Project	IEEE 802.16 Broadband Wireless Access Working Group < http://ieee802.org/16 >	
Title	802.16h Working Document Structure Reorganization	
Date Submitted	2006-07-21	
Source(s)	Wu Xuyong, Huawei Mariana Goldhamer, Alvarion Grandblaise David, Motorola John Sydor, CRC Avi Freedman, Hexagon	Voice:+86 755 28780808 Fax: mailto:wuxuyong@huawei.com
Re:	IEEE 802.16h-06/016 -Second Working Group Review: Working Document for P802.16h (2006-06-05)	
Abstract	The implementation result of contribution C80216h-06_046r1 within ad-hoc group [16h-TOC].	
Purpose	Show to be discussed in [16h-TOC] ad-hoc and will be the output of ad-hoc group after discussion.	
Notice	This document has been prepared to assist IEEE 802.16. It is offered as a basis for discussion and is not binding on the contributing individual(s) or organization(s). The material in this document is subject to change in form and content after further study. The contributor(s) reserve(s) the right to add, amend or withdraw material contained herein.

1
2
3
4
5 **Draft IEEE Standard for**
6 **Local and Metropolitan Area Networks**

7
8
9
10 **Part 16: Air Interface for Fixed**
11 **Broadband Wireless Access Systems**
12
13
14

15
16
1

Figure 219—Illustration of OFDMA frame with multiple zones

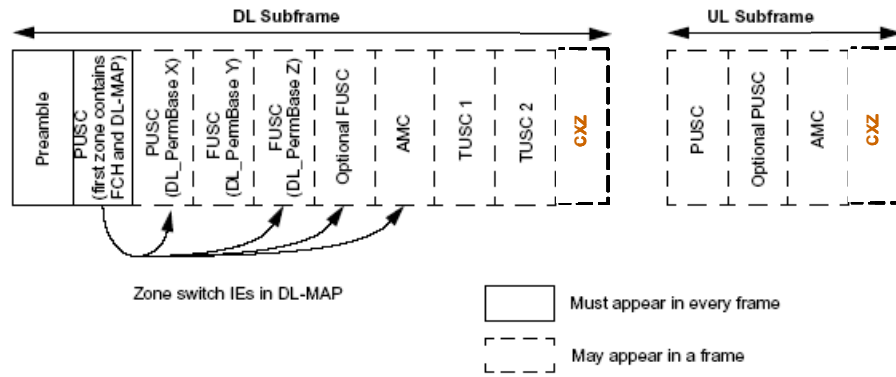
The OFDMA frame may include multiple zones (such as PUSC, FUSC, PUSC with all subchannels, optional FUSC, and AMC, CXZ, TUSC1, and TUSC2), the transition between zones is indicated in the DL-Map by the STC_DL_Zone IE (see 8.4.5.3.4), CXZ_DL_IE (see 8.4.5.3.11), or AAS_DL_IE (see 8.4.5.3.3). No DL-MAP or UL-MAP allocations can span over multiple zones. Figure 219 depicts the OFDMA frame with multiple zones.

[change figure 219 as following:]
